**RE: Chase Bank – Indian School Rd.
6670 Indian School Rd. NE
Grading and Drainage Plan
Engineer's Stamp Date: 10/08/20
Hydrology File: J18D001C**

Based upon the information provided in your submittal received 10/08/2020, the Grading & Drainage Plan **is not** approved for action by the DRB on Site Plan for Building Permit. The following comments need to be addressed for approval of the above referenced project:

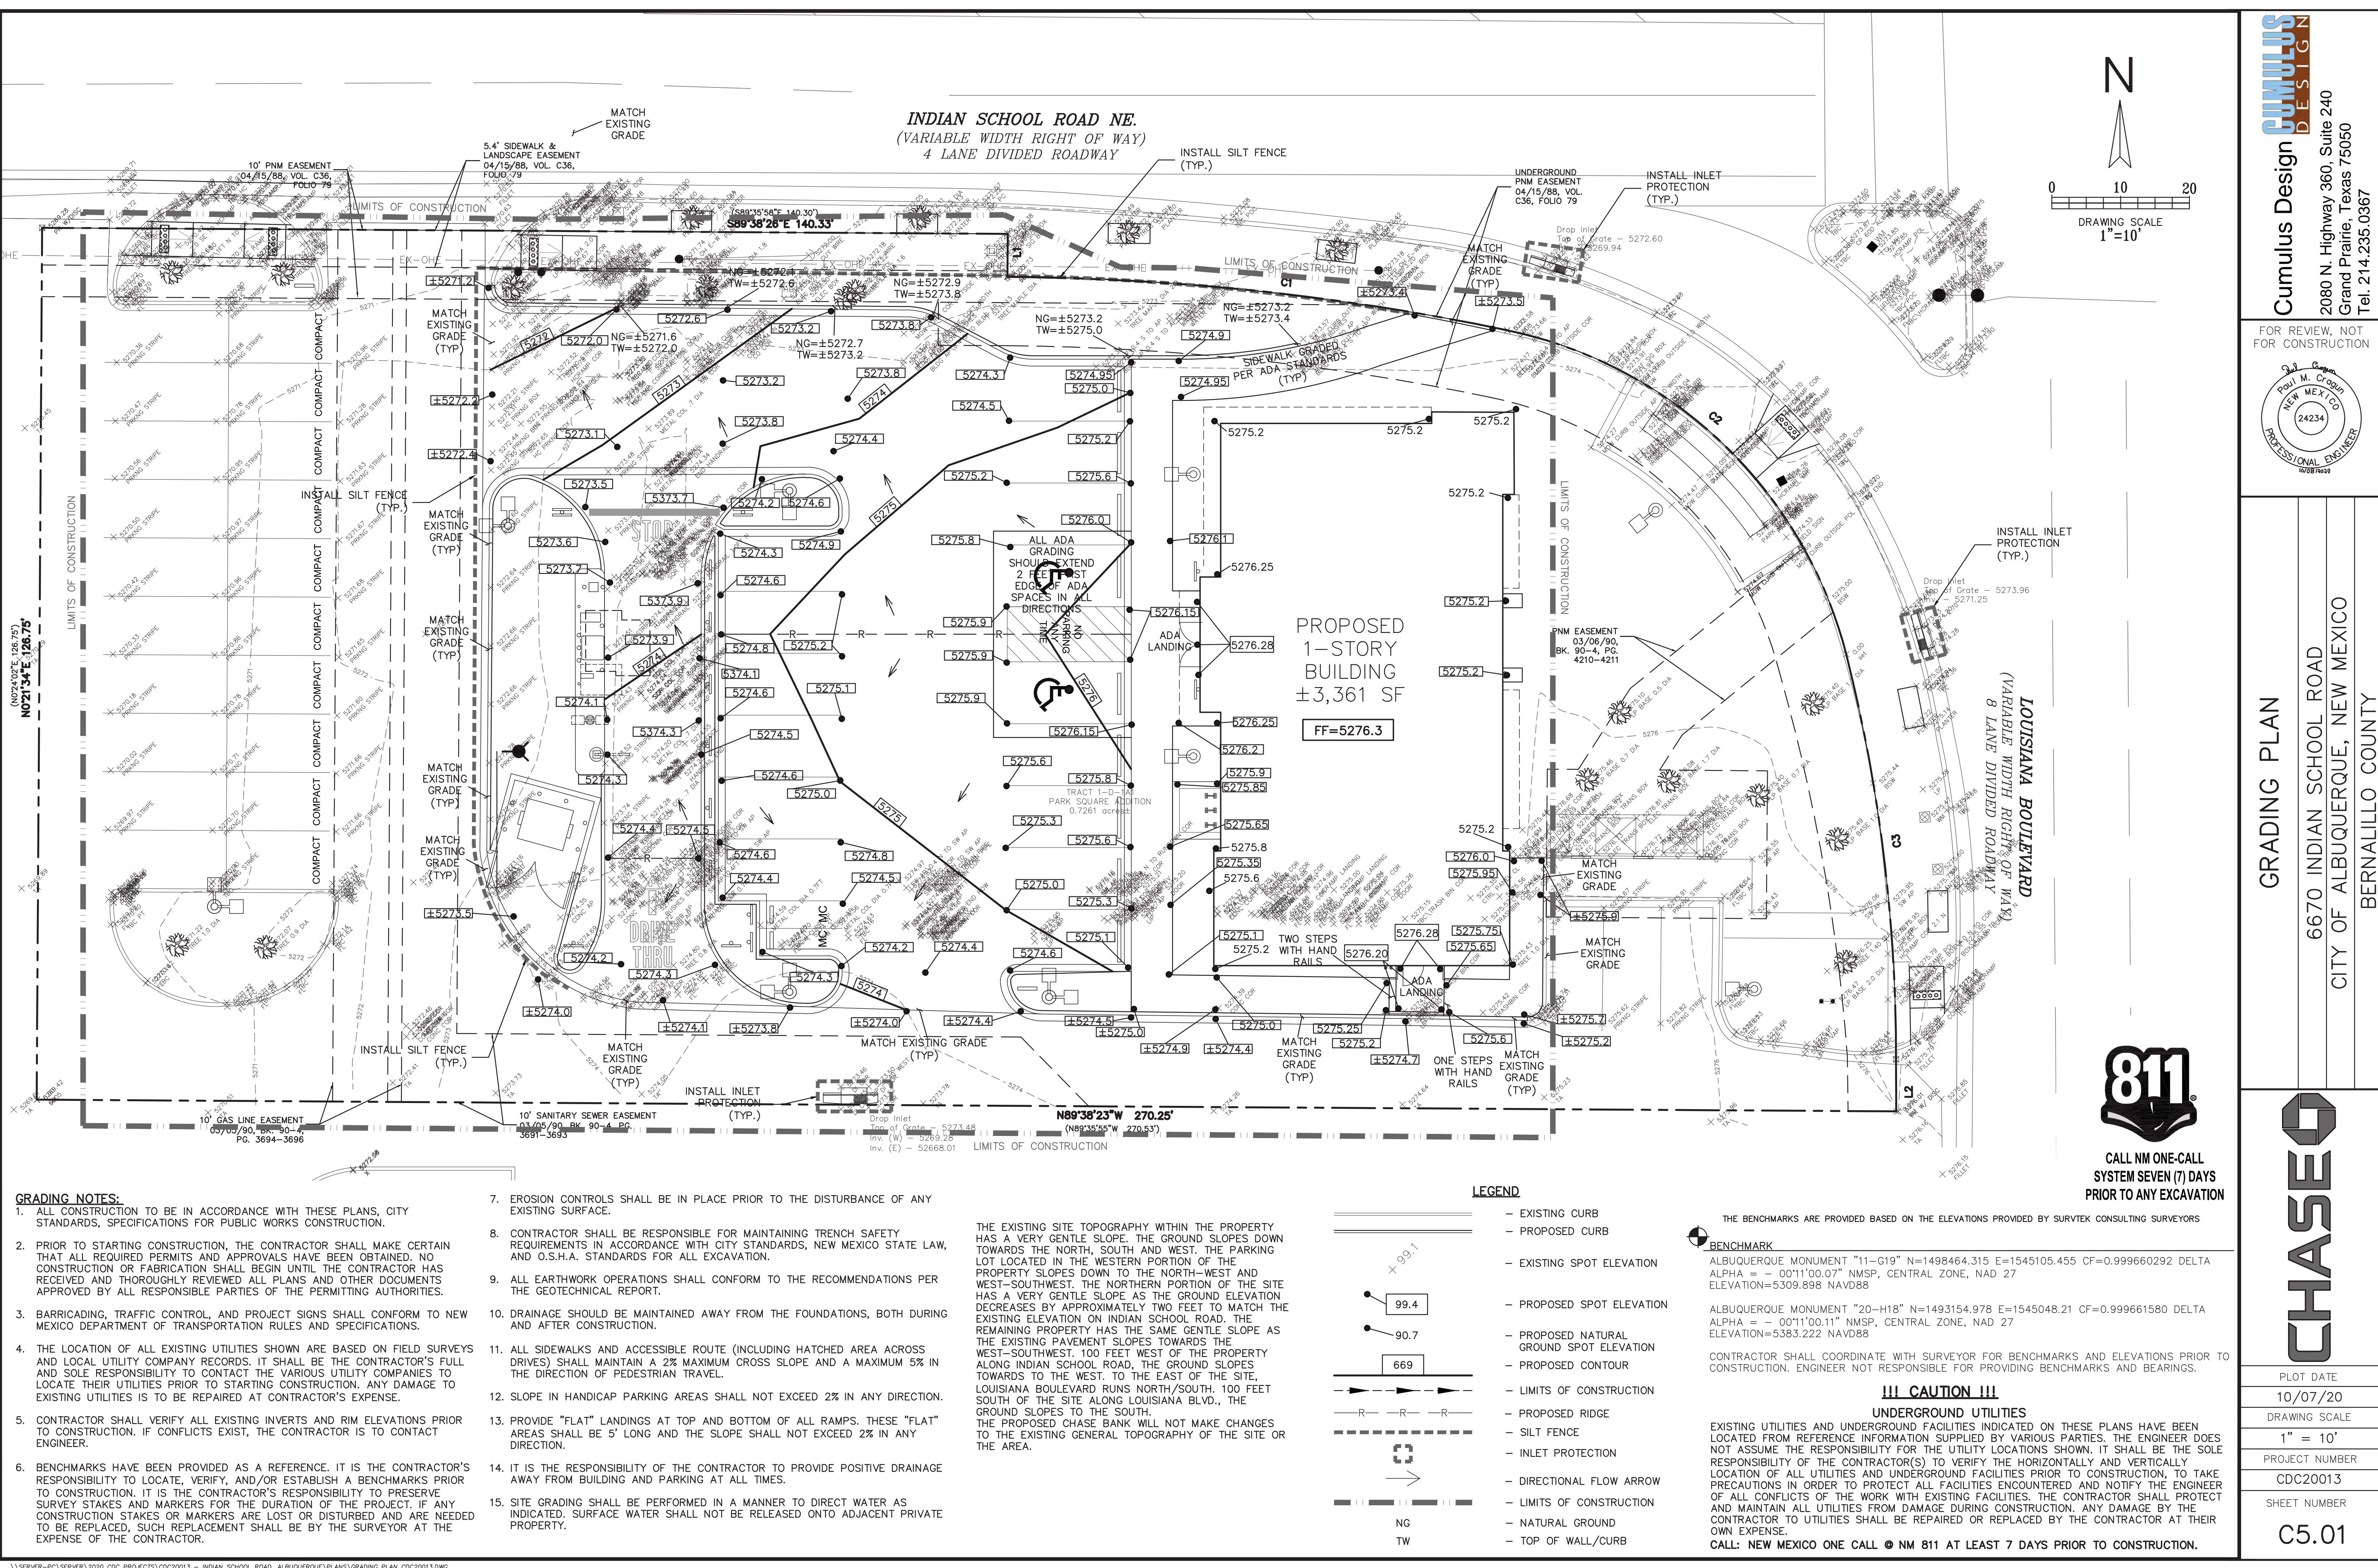
3. Please show the edge of saw cut of the existing pavement and label along this, "Match existing grades". It is currently unclear where the area of construction is starting/stopping.

4. On the Grading Plan, please shade back the existing survey points. It is hard to read what is being proposed.
5. As a reminder, if the project total area of disturbance (including the staging area and any work within the adjacent Right-of-Way) is 1 acre or more, then an Erosion and Sediment Control (ESC) Plan and Owner's certified Notice of Intent (NOI) is required to be

DRAINAGE AREA MAP

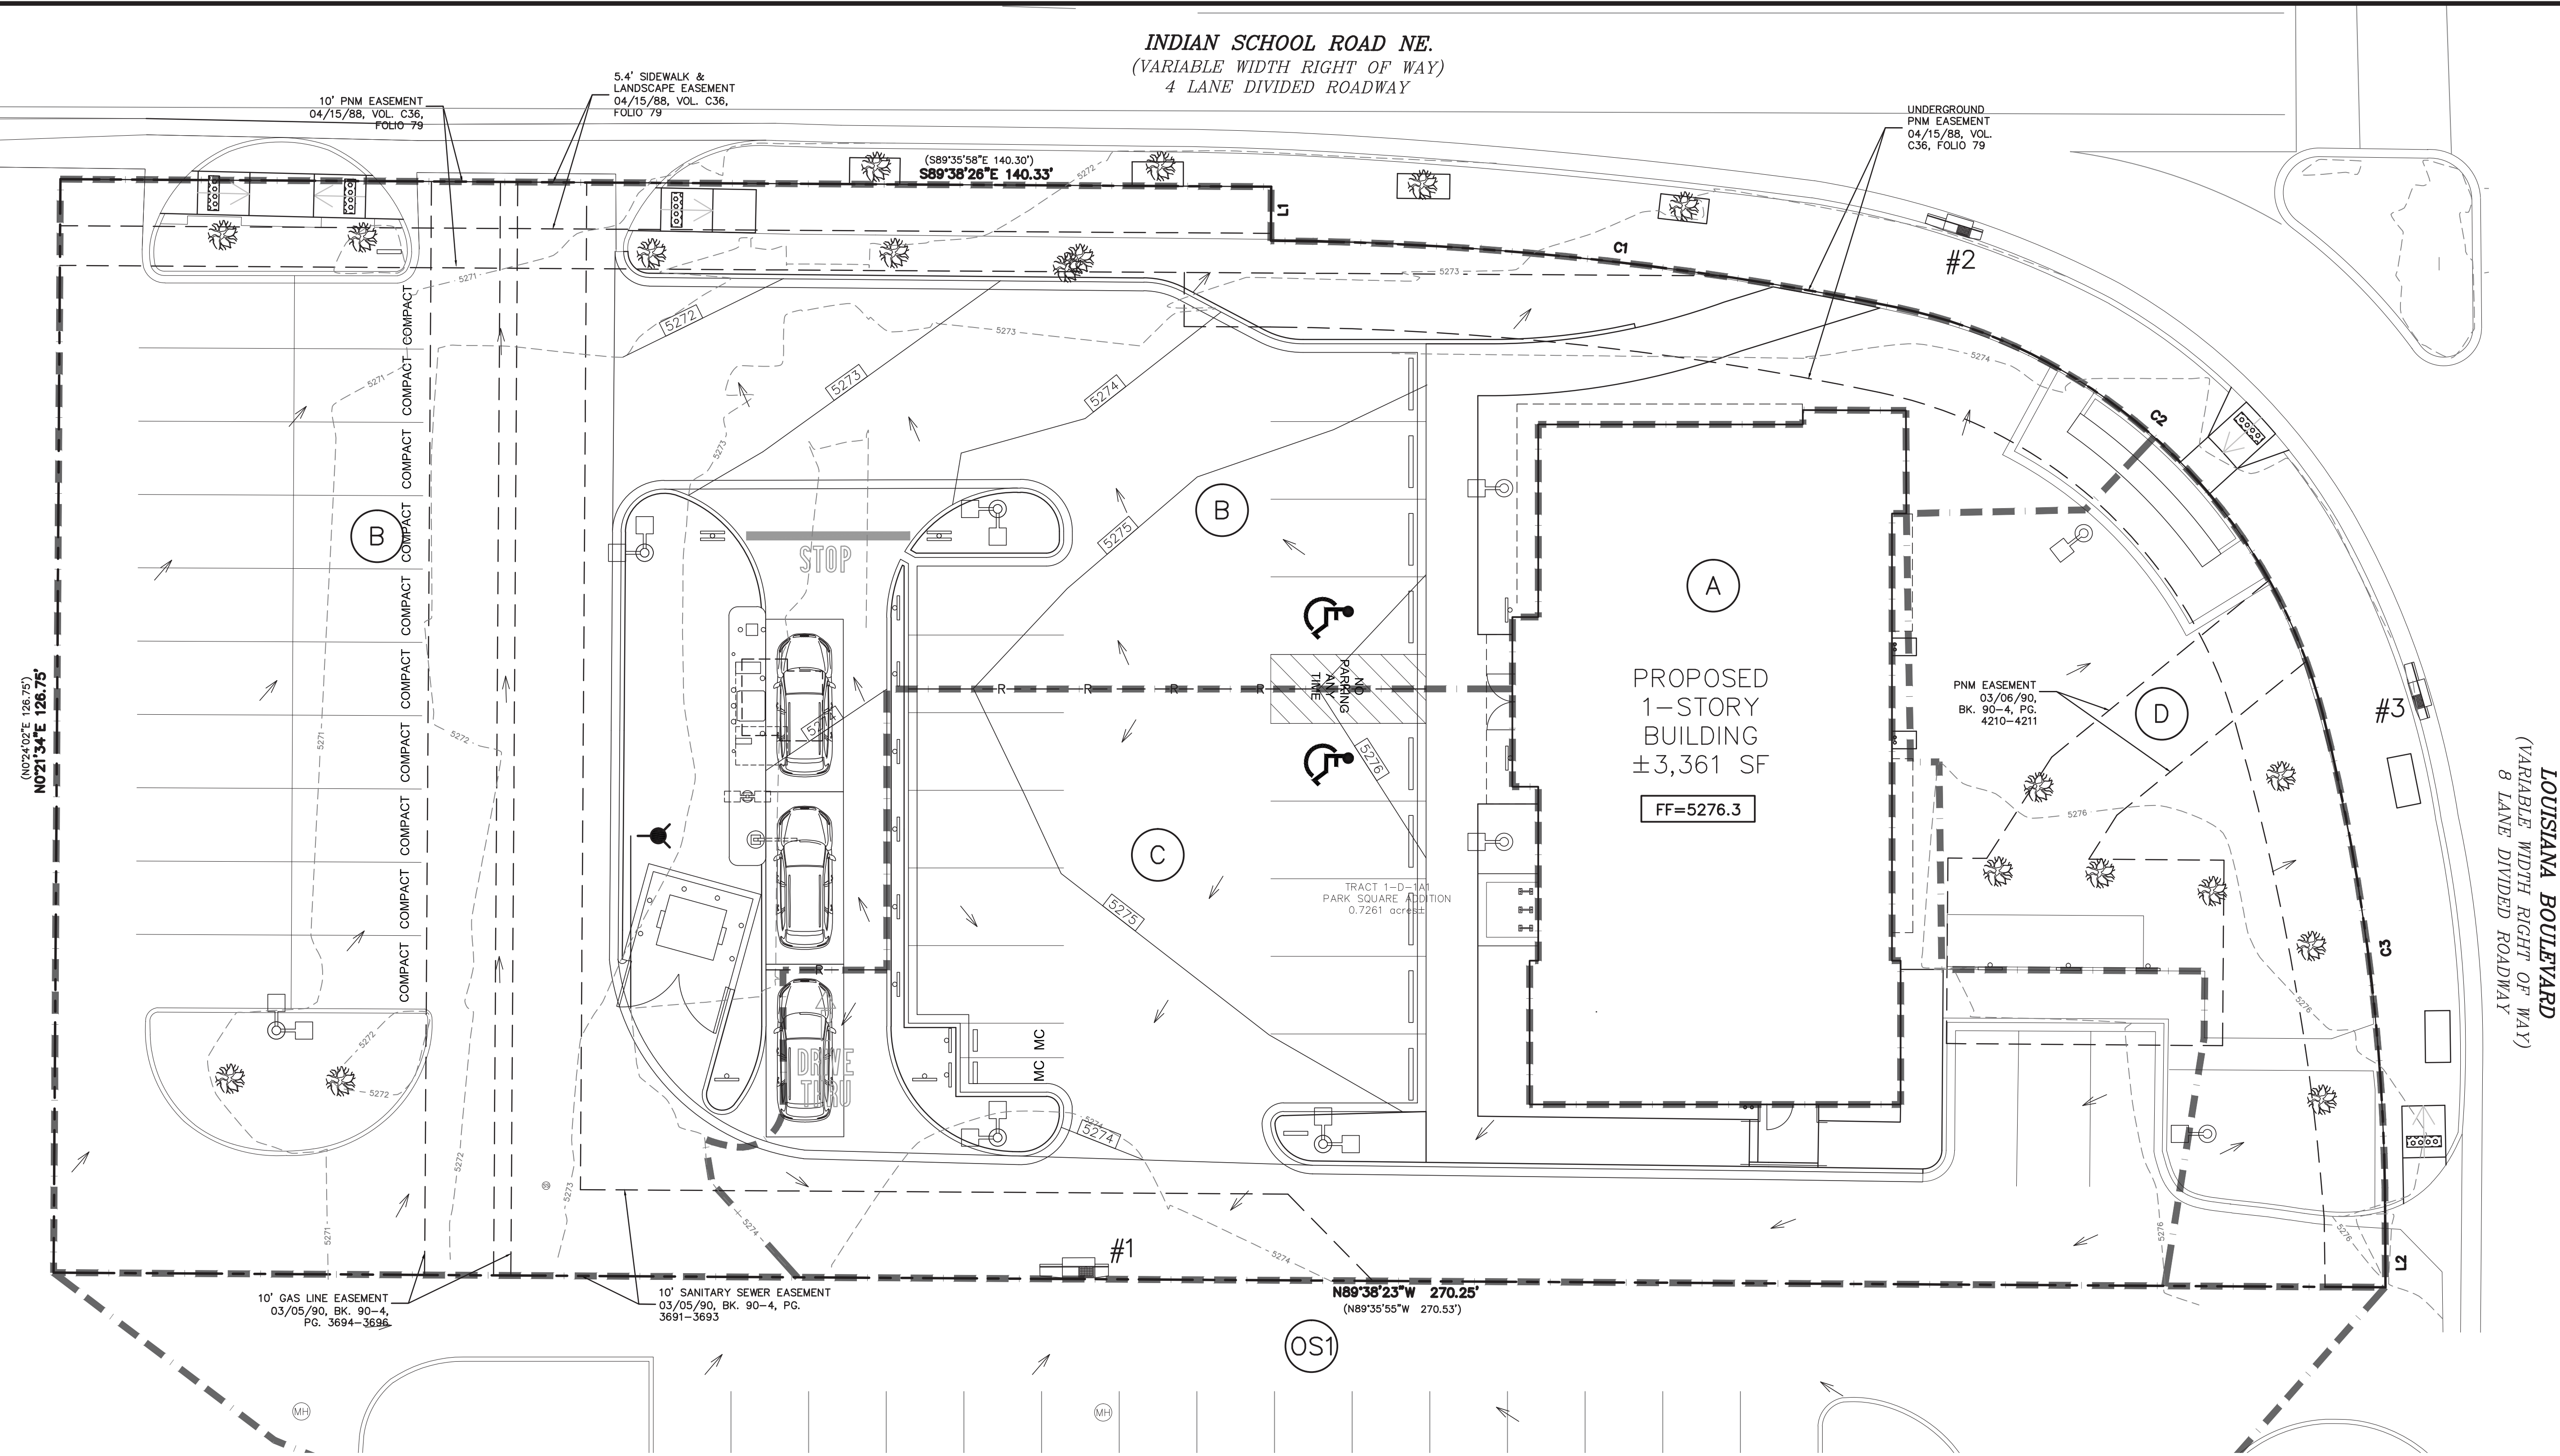
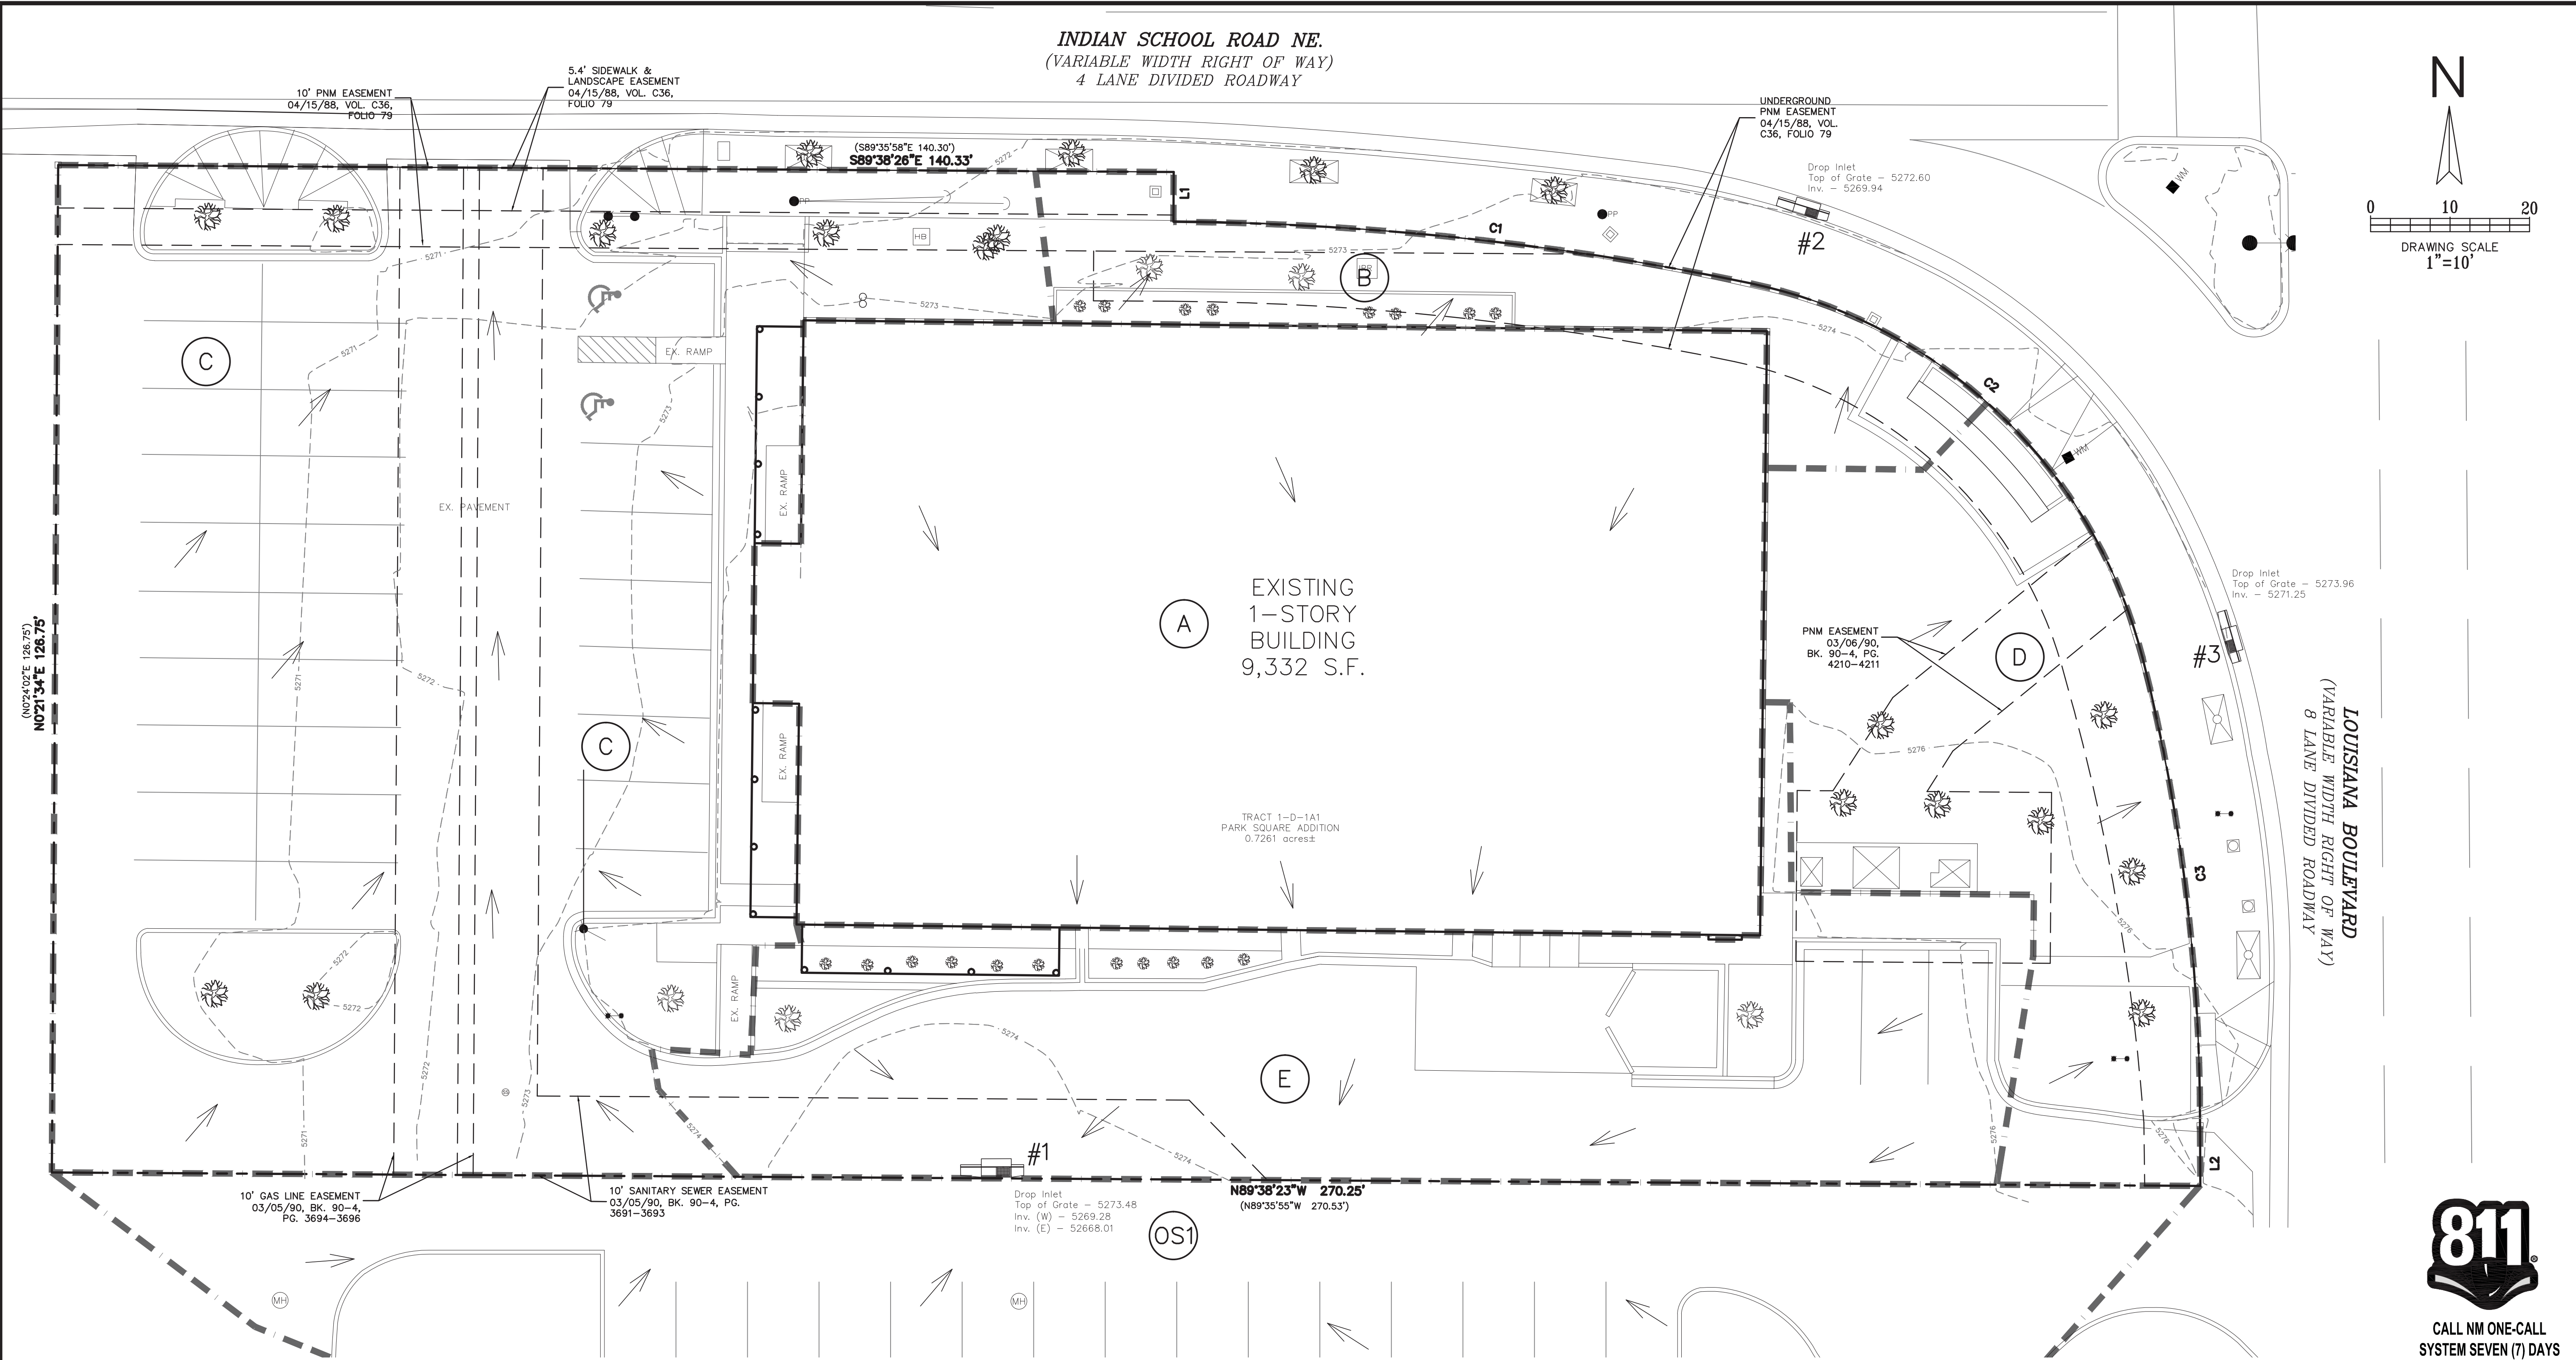
1. Please use the procedure for 40 acre and smaller basins as outlined in Development Process Manual (DPM) (signed 06/08/20) Article 6-2(a). Please provide both the existing conditions and proposed conditions for the 100-year 6 hour storm event.

2. Provide management onsite for the Stormwater Quality Volume (SWQV) in accordance with the new drainage ordinance, § 14-5-2-6 (H) enacted 10/2/18 (Council Bill C/S O-18-2) and as outlined in DPM (signed 06/08/20) Article 6-12 Stormwater Quality and Low-Impact Development for the sizing calculations. Since this site is a redevelopment the SWQ pond volume will be $0.26 * \text{new impervious area (sf)} * 1/12$. Please show the top and bottom of the ponds along with the volume for each pond. The onsite drainage should be directed to these ponds prior to either being collected in the existing inlet or leaving the site for the public drainage system.
